8300 Wisconsin Ave (AKA Trillium), Project/Preliminary/Site Plan Amendment, 92006006A/12006040A/82006036B

Date of Staff Report: 04/23/2012

Description

*Exhibit showing types and general locations of artwork to be incorporate within project
(The numbers correspond with text below)*

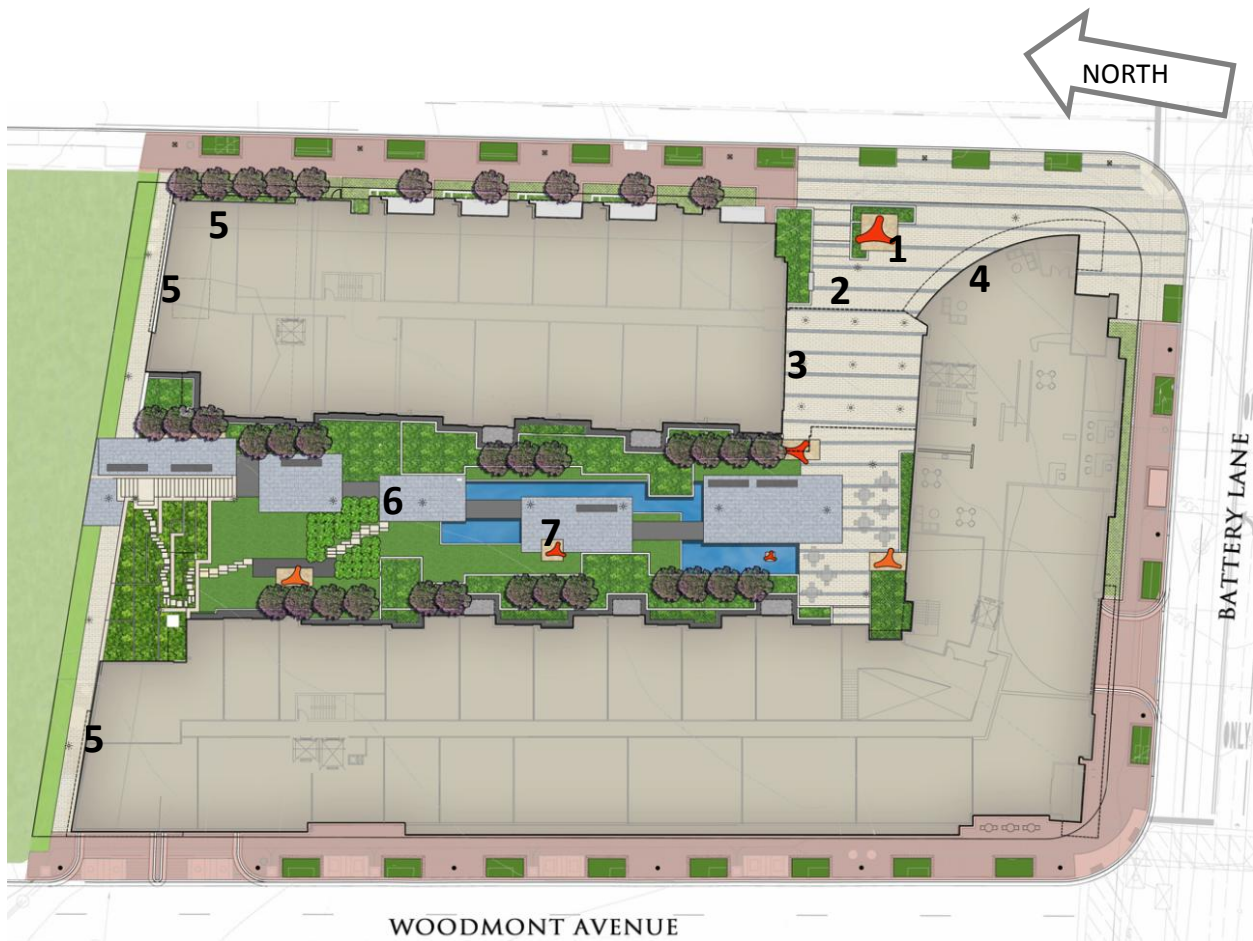
A condition in the report addresses the type, location, quantity, programming and maintenance of the artwork and building ornamentations to ensure the associated objectives are achieved.

The final designs of all artwork and sculptures to be approved by the art panel in coordination with M-NCPPC staff. Final locations, type quantities to be determined prior to certified site plan.

Truncation

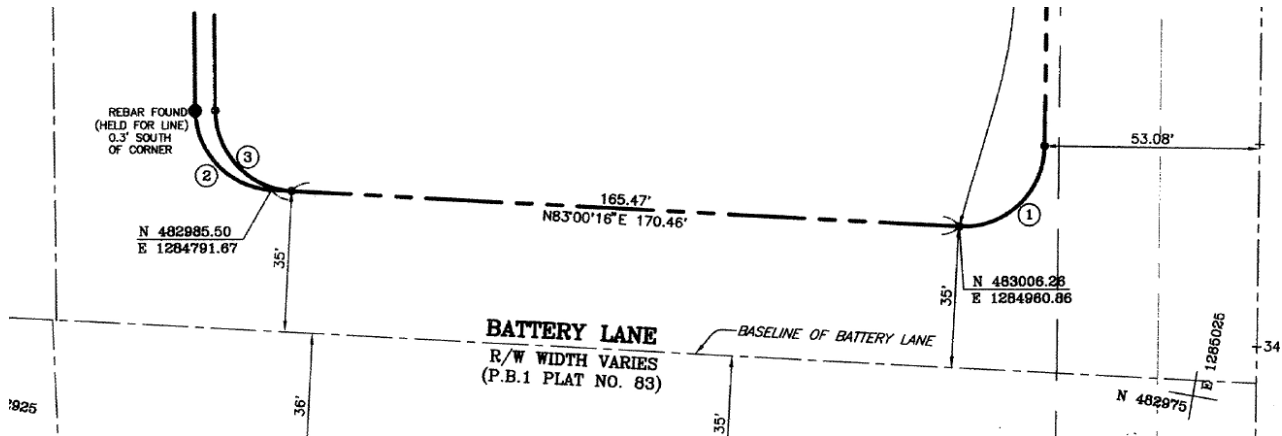
Pursuant to Section 50-26(c)(3) of the Subdivision Regulations, a 25 foot truncation at the corners must be shown, unless the Planning Board determines that a different amount is needed for safe site

distance or traffic channelization. As a result of the original application, the truncation was not required and the property corners relative to the intersections were platted with an approximately 20' radius as shown in the image below.

However, there are numerous factors in both the proposed design and County policy/goals which now would warrant full truncation of the intersections. However, an alternate design concept has been proposed by the applicant which provides a similar function as the truncation, and is acceptable to Staff.
